Land to the Northwest Of Factory Road, Northfleet Works, The Shore, Northfleet, Gravesend, Kent

Project/File: 332612492
Date: 24th July 2025
Prepared By: K State
Reviewed By: J Lewis
Subject: **Transport Technical Note 2 – Response to Comments from Kent County Council**

Proposed Site Layout - Ground Floor Plan

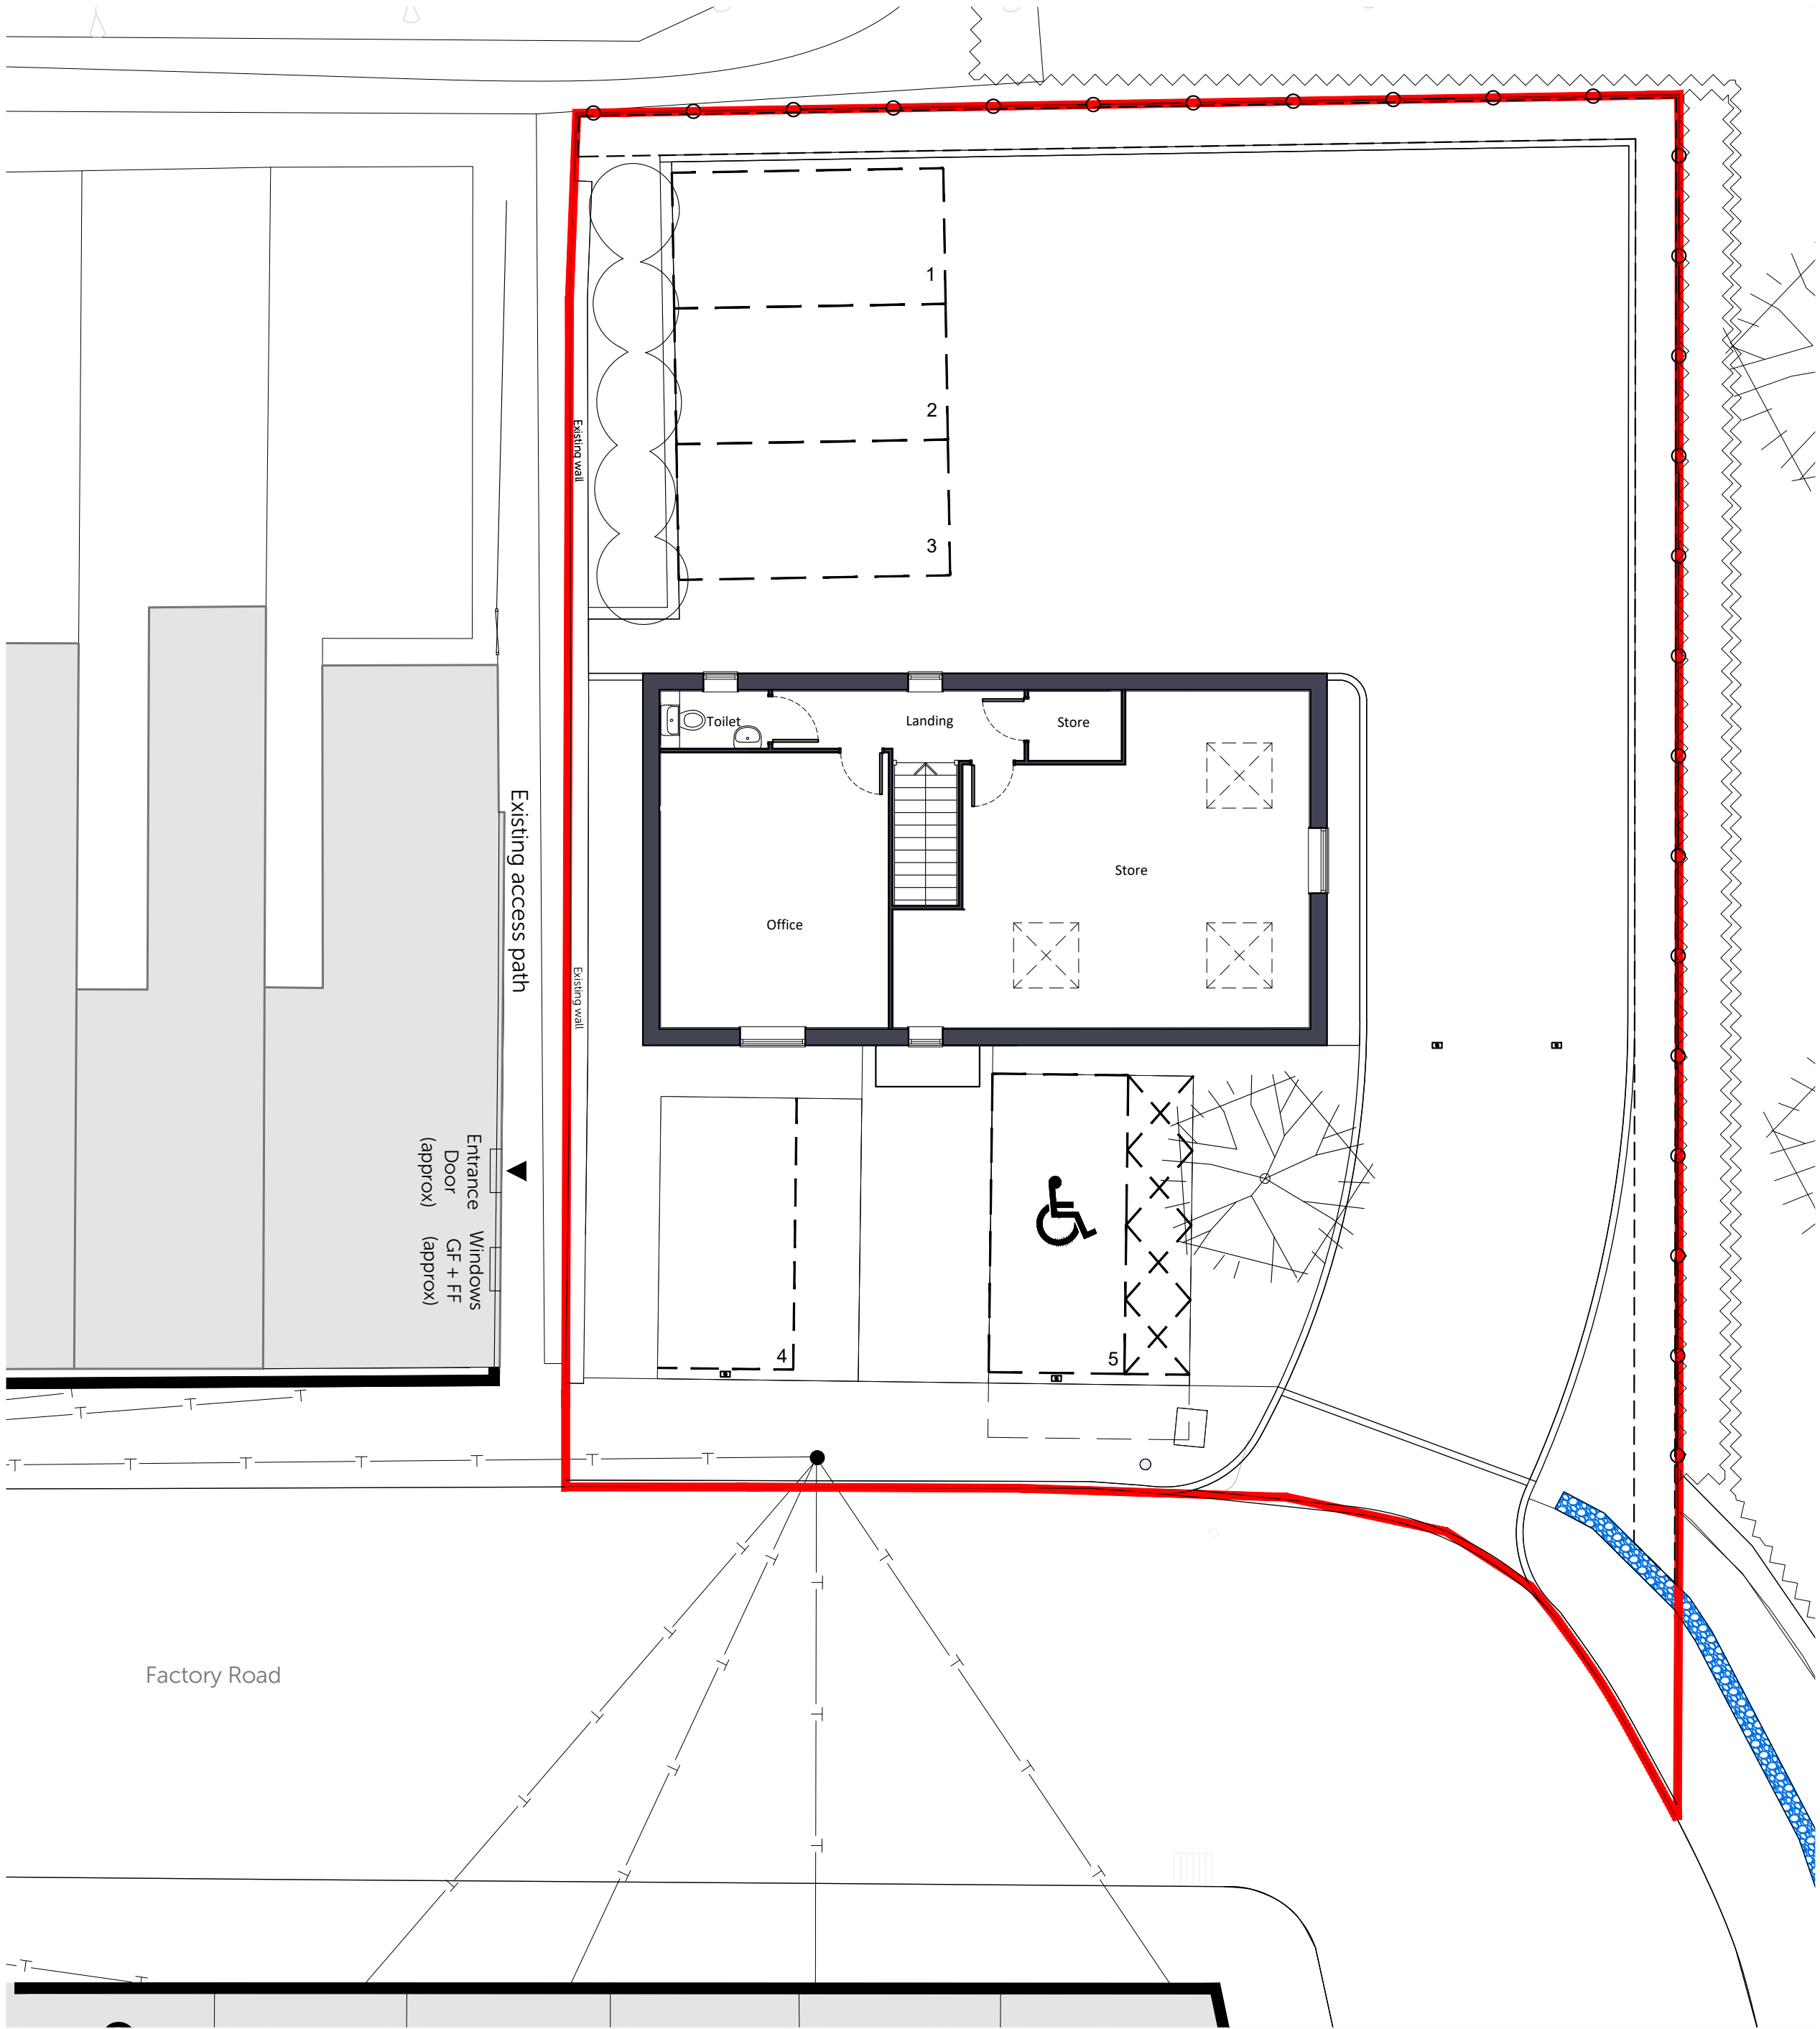
No dimensions are shown for the parking bays. In line with KCC's standards, these should be 2.5m x 5m. The parking space at the eastern end of the row appears to be abutting a hard boundary / vegetation and should therefore have an additional 0.2m in width to assist manoeuvring into and out of the space. Disabled parking bays should be 5.5m in length and 3.7m in width (including hatching). The dimensions should be shown on a plan to demonstrate they are achievable.

2.8 Parking space dimensions are now provided in the landscape design (see **Appendix C**). Additional width and length for the parking spaces abutting vegetation and the disabled bays, respectively, have been provided as per KCC's requirements.
